# **Regulation 25 Environmental Statement Addendum**

**Spring Grove AD Facility, Thurlow**

**Acorn Bioenergy Limited**

14 January 2025

#### Location of Alternatives Sites and the Proposed Development Site

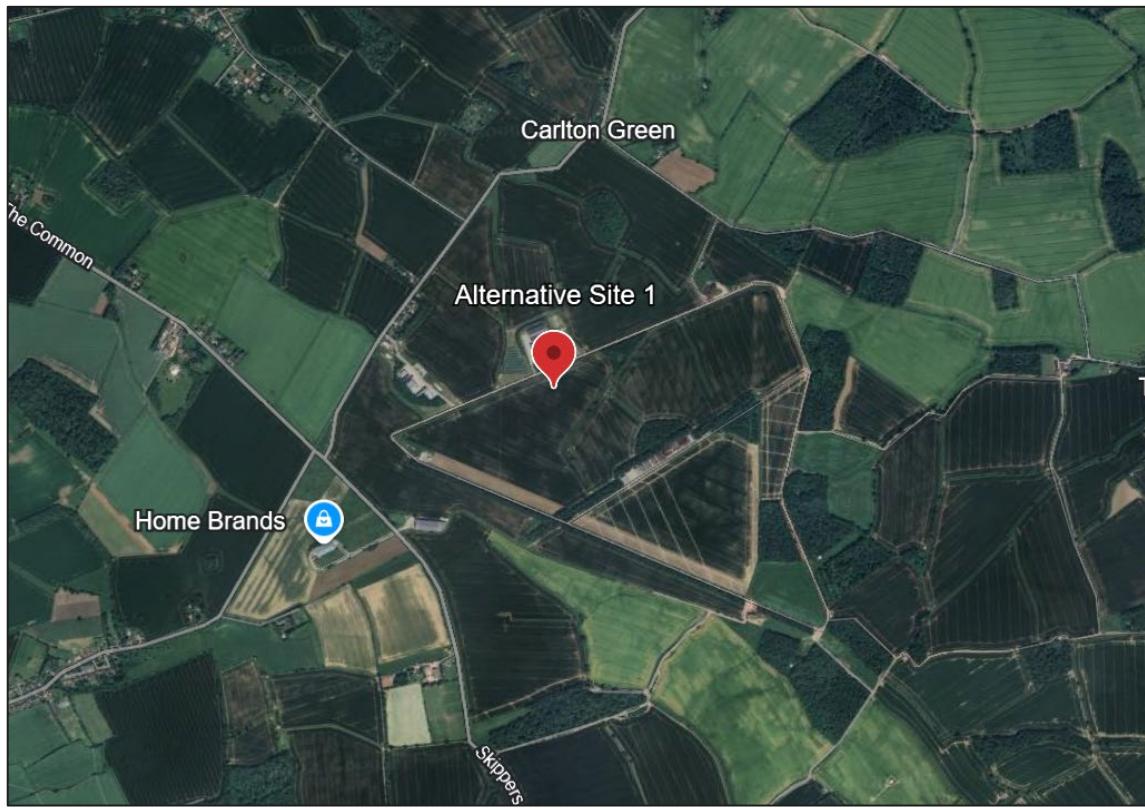
Alternative Site 1 is located approximately 3.3km north of the proposed development Site and comprises 5.69ha of agricultural land which can be accessed via Common Road (South). This

Notwithstanding the above, the site location is acceptable from an environmental perspective including (not exhaustive) its location outside of any environmental designations, being within a low flood risk (Zone 1), being outside the agricultural land classification 1 and being at a considerable distance (approximately 0.9km) from any heritage receptors. However, there are receptors such as commercial and dwelling receptors within a close vicinity. Several of the environmental characteristics are also comparable for the proposed site at Spring Grove Farm. However, the adverse impact and operational disadvantages of this site owing to accessibility mean the proposed site is preferable.

### Alternative Site 2

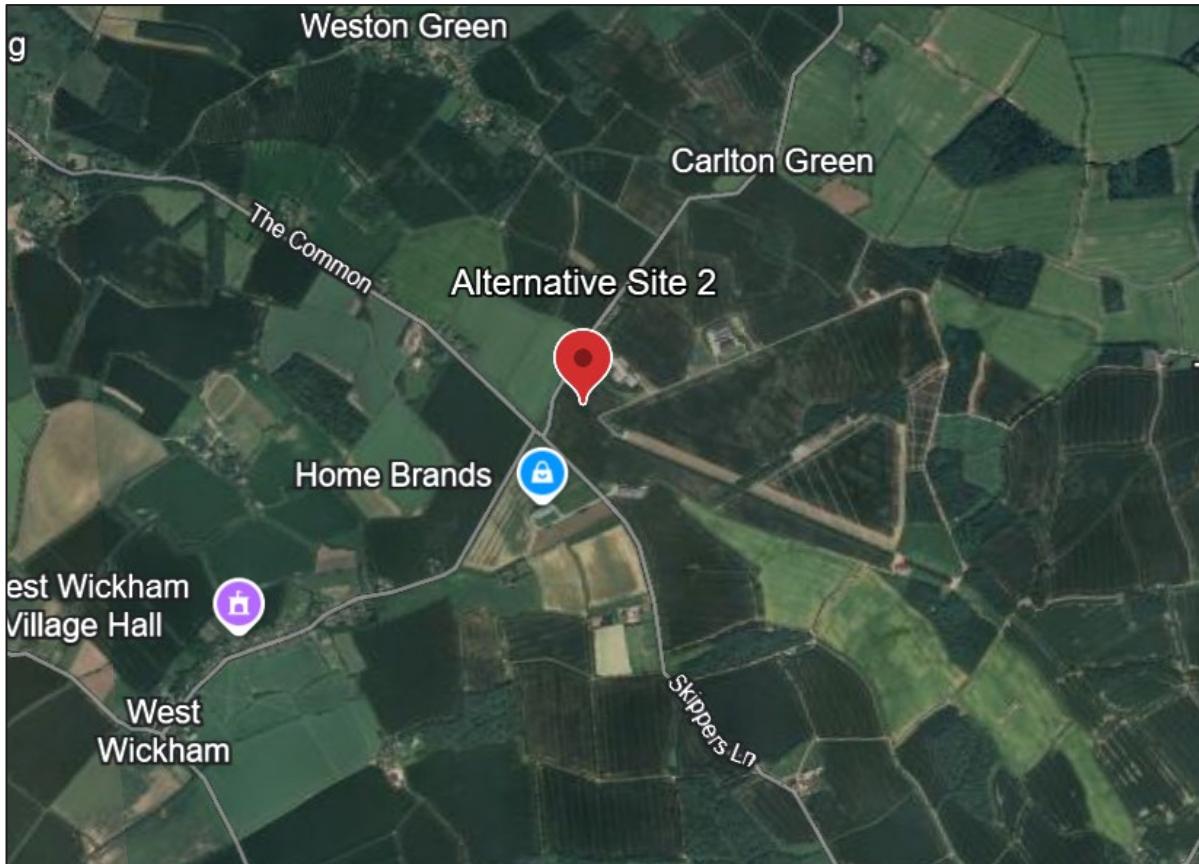
The second alternative Site considered is located approximately 0.31km to the West of alternative site 1. The alternative site also comprises agricultural land (4.95ha) and is located off an unnamed road off Common Road where it can be seen from Common Road and Skippers Lane.

**Alternative Site 2 location (accessed from an unmade road that adjoins Common Road to the Northwest and visible from Skippers Lane to the Southwest)**

Also similar to alternative site 1, the site location is acceptable from an environmental perspective including (not exhaustive) its location outside of any environmental designations, being within a low flood risk (Zone 1), being outside the agricultural land classification 1 and being at a considerable distance (approximately 0.6km) from any heritage receptors. However, there are receptors such as commercial and dwelling receptors within a close vicinity. Several of the environmental characteristics are also comparable for the proposed site at Spring Grove Farm. However, the adverse impact and operational disadvantages of this site owing to accessibility mean the proposed site is preferable.
